Shasta Dam Temperature Modification
Value Engineering Study
September 4, 1987

SHASTA DAM TEMPERATURE MODIFICATION
VALUE ENGINEERING STUDY
SEPTEMBER 1987

D-251 Drake's Comments On
Shasta Dam Temperature Modification
Value Engineering Study
September 1987

Figure 10. Francis Turbine Installation in Existing Low Level Reservoir Outlet

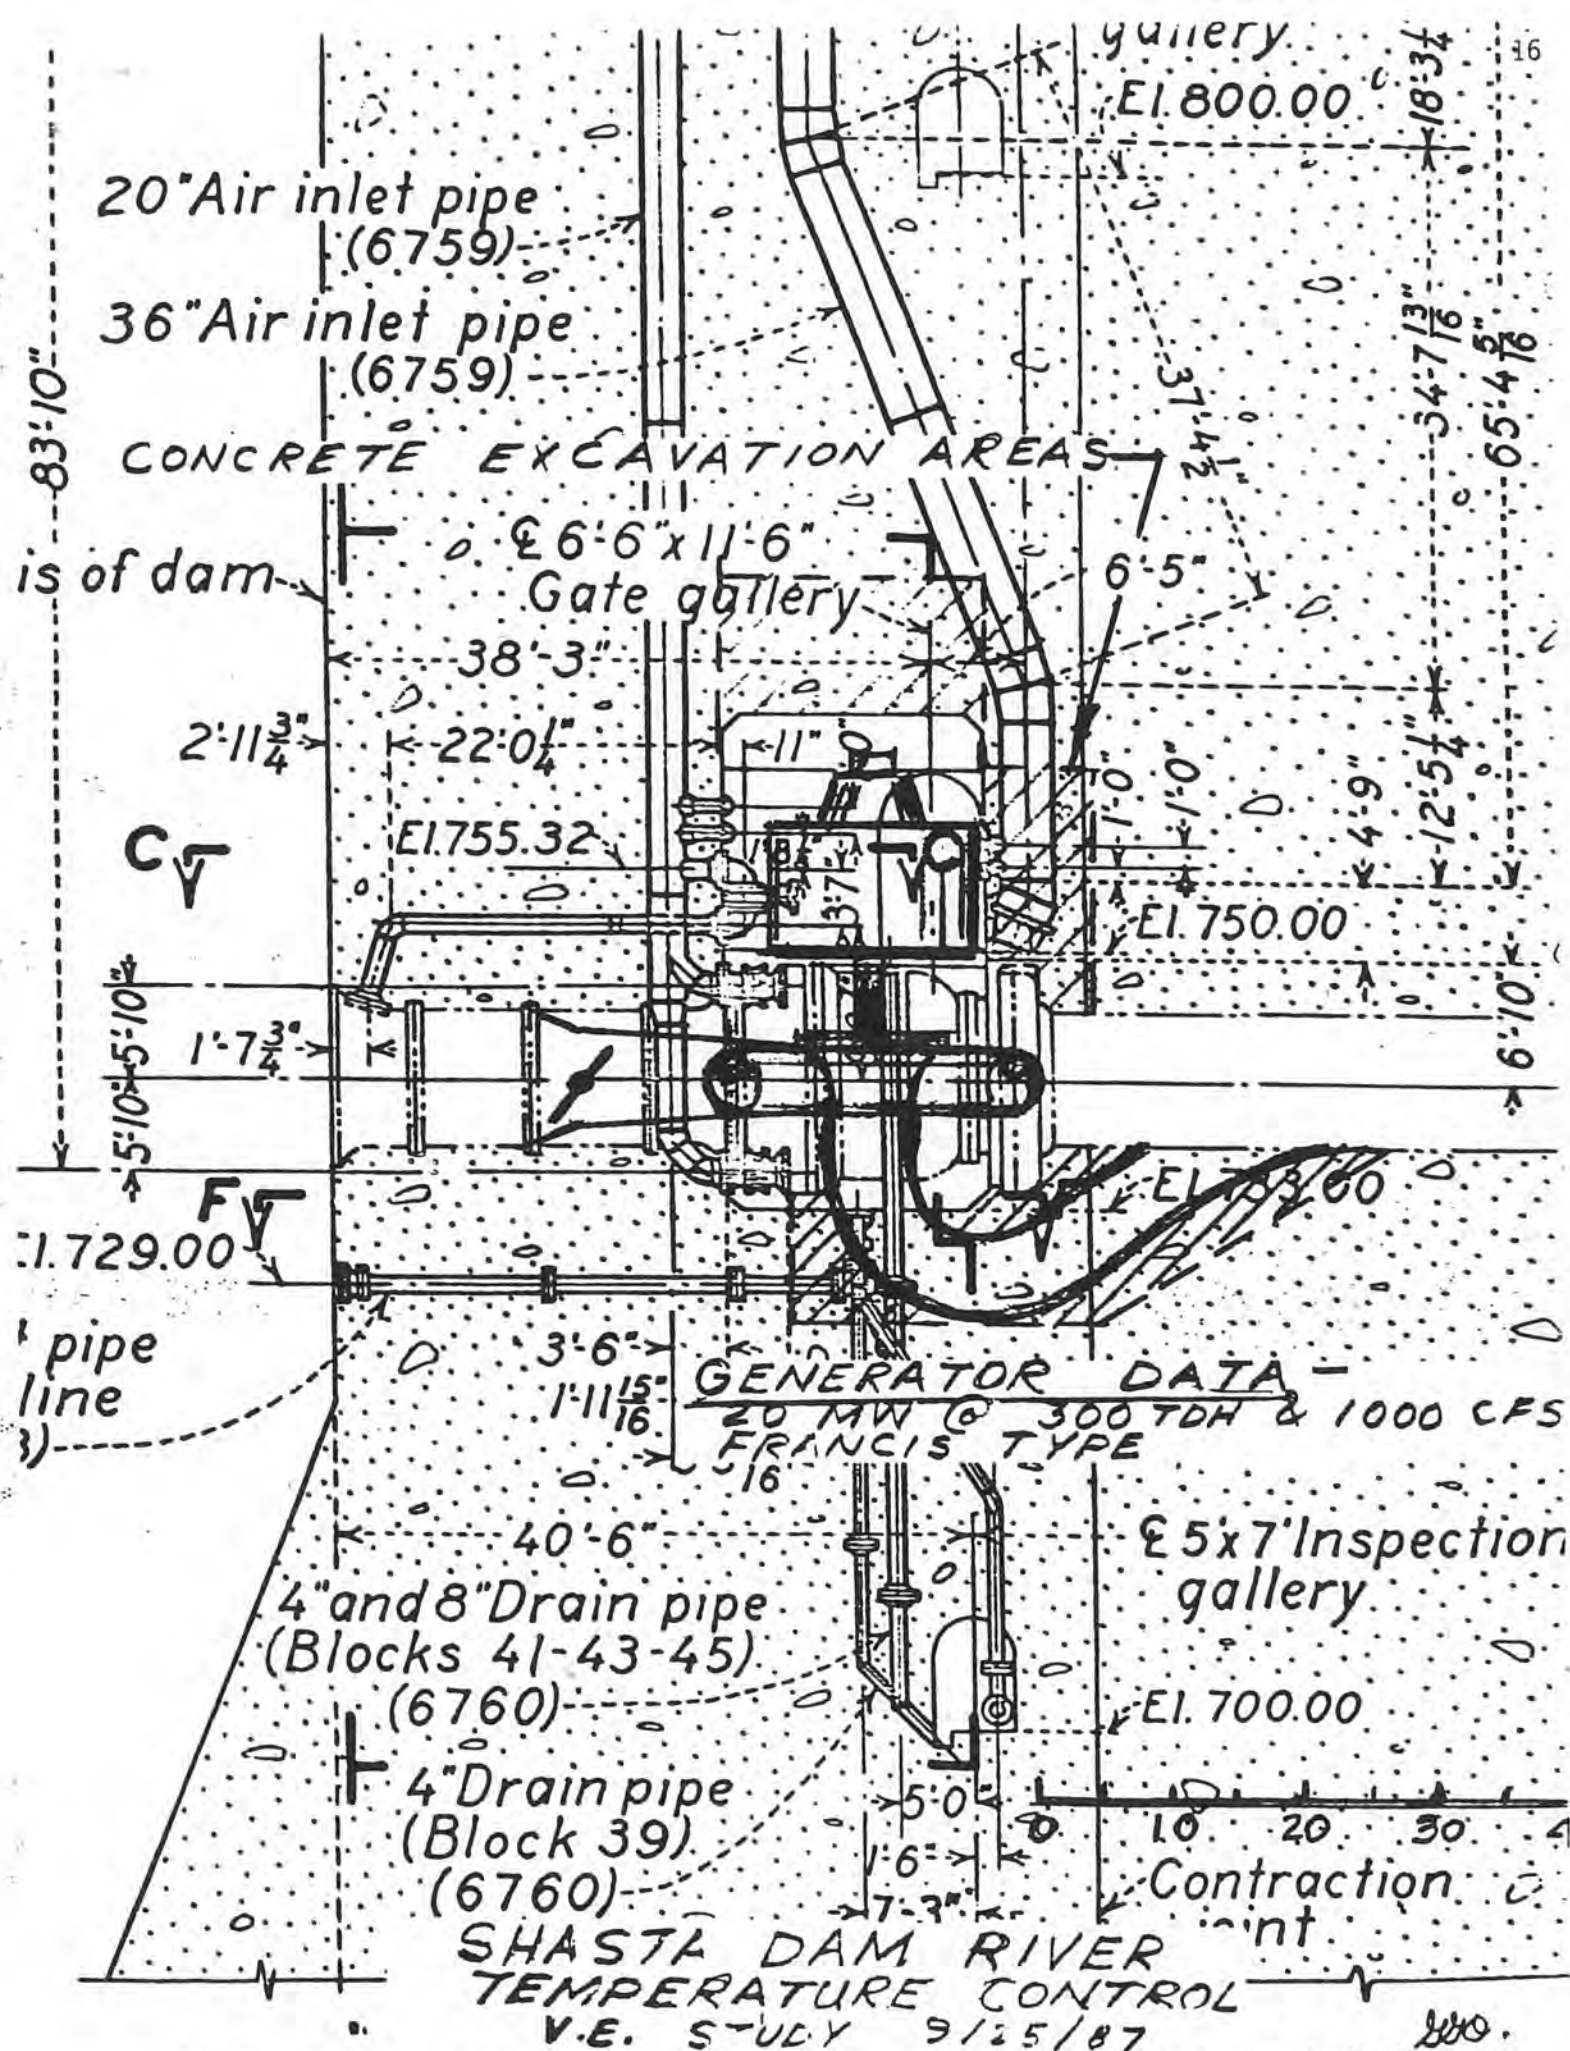
1. Reaction turbines, such as shown on Figure 5, require that the discharge of the draft tube be submerged below minimum tailwater elevation. Since the river outlet pipes discharge above minimum tailwater we question whether the necessary hydraulic condition exists. Perhaps the condition could be set up within the outlet pipe downstream from the potential powerplant. If not, additional turbine generator units might be constructed on the left side of the dam and connected to the outlet pipes with a penstock. The small amount of time that a new unit would operate, either during times of temperature control or spills, probably would not justify the cost.
